TCC Oulu
Kare Oksanen

Oct 3, 2002

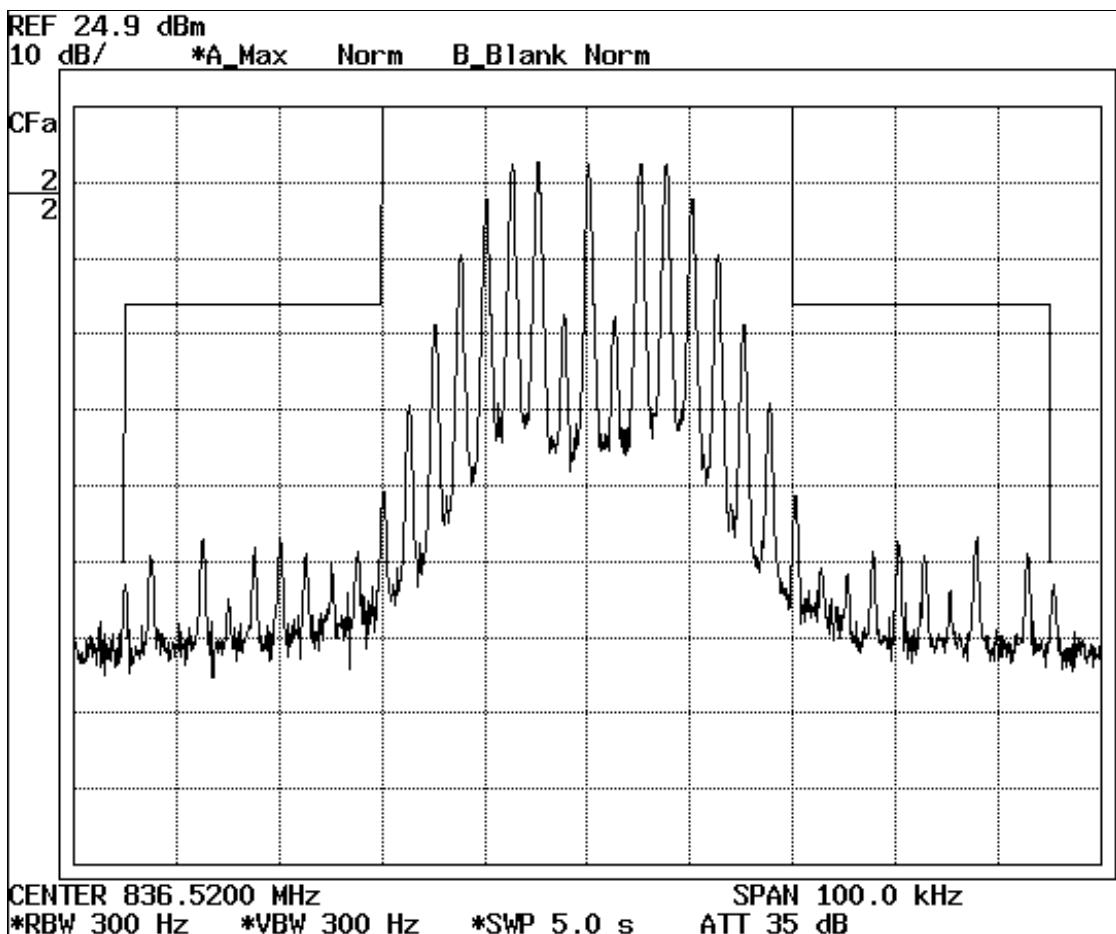
3 The voice bandwidth plot on page 21 of the report does not seem to have the typically expected characteristics of a 2500Hz modulated signal. Please explain.

It looks like 2500Hz sine wave was overdriven with too high signal level. Below is the plot with correctly leveled 2500Hz sine wave.
